SERVICE BULLETIN

Inspection and/or replacement of the valve push-rod assy., rocker arm left and rocker arm right for ROTAX® Engine Type 912 i, 912 and 914 (Series)

ATA System: 72-30-00 Cylinder head

Fig. 1
Visual inspection

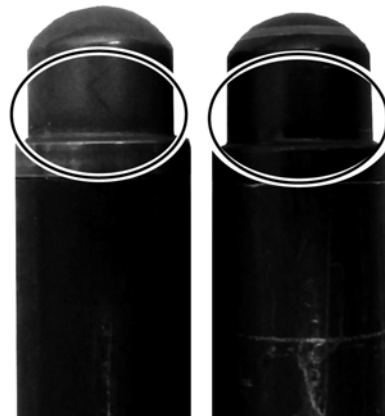
Perform visual inspection of all push-rod ball sockets on all cylinder.
 Check for color. See Fig. 1.

Color	Evaluation
Silver surface	Valve push-rod is OK. No further action required for this valve push-rod.
Black surface	Valve push-rod is NOT OK. See section. 3.1.3) Replacement of affected parts.

GOOD
(silver color)

BAD
(black color)

Fig. 2

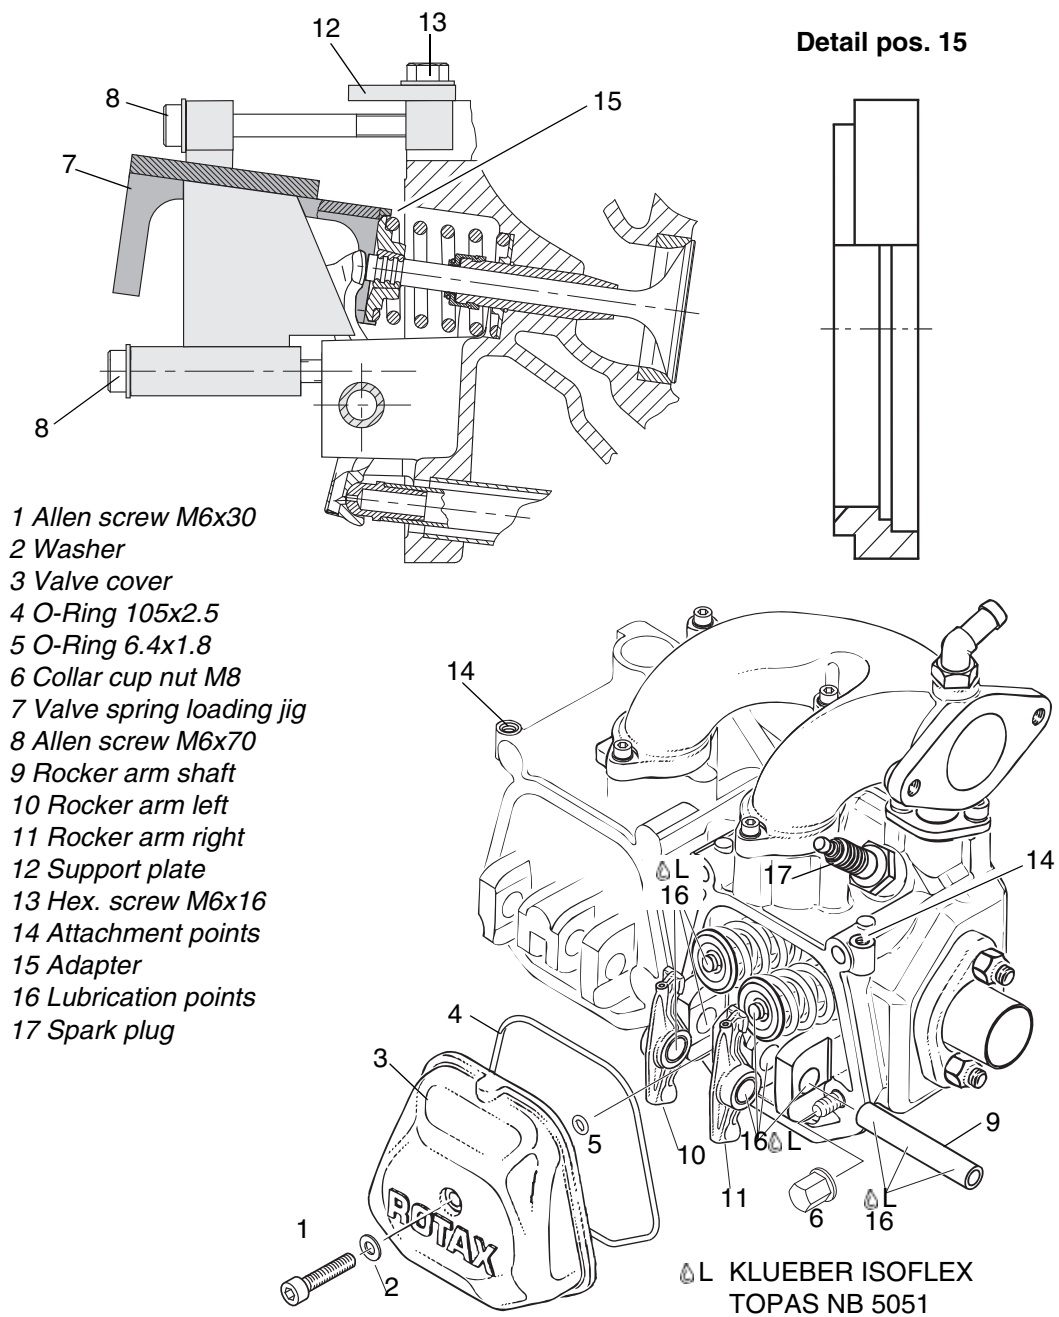
Step	Procedure
1	Loosen Allen screw (1) M6x30 with washer (2) from valve cover (3), and remove it together with large and small O-rings (4) and (5).

Step	Procedure
3	Attach the support plate (12) to the valve spring loading jig part no. 877387 (7) with 2 hex. screws (13) M6x16 at the attachment points (14) on the cylinder heads.
4	Put adapters (15) on the valve spring loading jig.
5	Attach the valve spring loading jig on cylinder head and support plate with 2 Allen screws (8) M6x70 and depress both valves with 3 turns.

Step	Procedure
6	This will relieve the pressure from both hydraulic tappets. Now the rocker arm shaft (9) may be easily pulled out. Lift out both rocker arms (10) and (11).
7	Replace only affected parts as per section 2.3 . See also Fig. 3 .
8	Apply KLÜBER ISOFLEX TOPAS NB 5051 (16) on both push-rod ball sockets and contact areas of rocker arm and slide push-rod into the oil return tube (20).
9	Check bushing and rocker arm shaft according to latest Maintenance Manual Heavy.
10	Put oil on the rocker arm bushing.
11	Place rocker arm left (10) and rocker arm right (11) in cylinder head, apply KLÜBER ISOFLEX TOPAS NB 5051 (16) on rocker arm shaft (9) and insert it into its bearing support.
12	Loosen valve spring loading jig and support plate.
13	When removing the valve spring loading jig, make sure the adapter rings (15) do not jam on the valve spring retainer.
14	NOTE: Only when you have an Criterion B) Spare parts affected engine and only if engine is equipped with collar cap nuts M8 wrench size 13: Mount collar cap nut (6) according to latest Maintenance Manual Heavy or SI-912-025/SI-914-026/SI-912 i-010.

Step	Procedure
1	Clean the sealing surface of cylinder head and valve cover with a suitable lint-free cloth or equivalent.
2	Insert new O-ring (4) 105x2.5 and O-ring (5) 6.4x1.8 into the valve cover (3).
3	Fit valve cover.

Step	Procedure
4	Tighten the new Allen screw (1) M6x30 with washer (2) to 10 Nm (89 in.lb).

Fig. 3

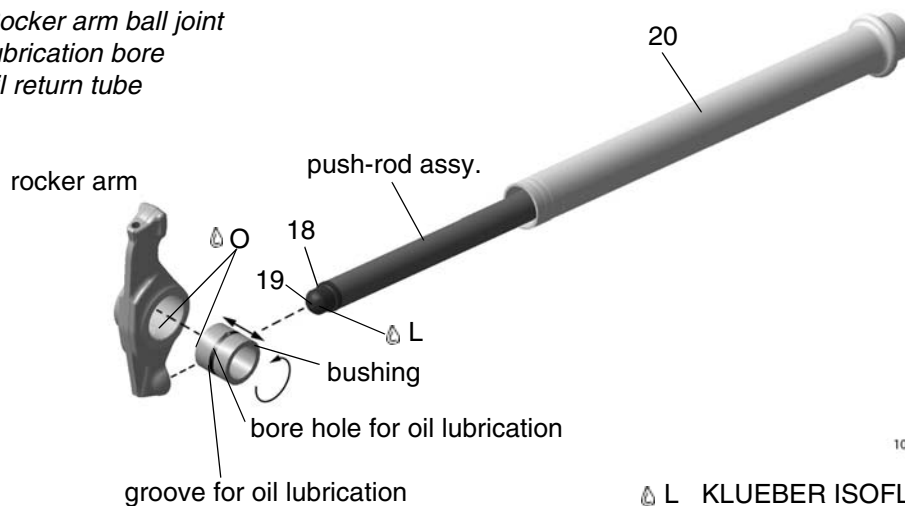
15	Lubricate all moving parts in the rocker arm space with engine oil or equivalent.
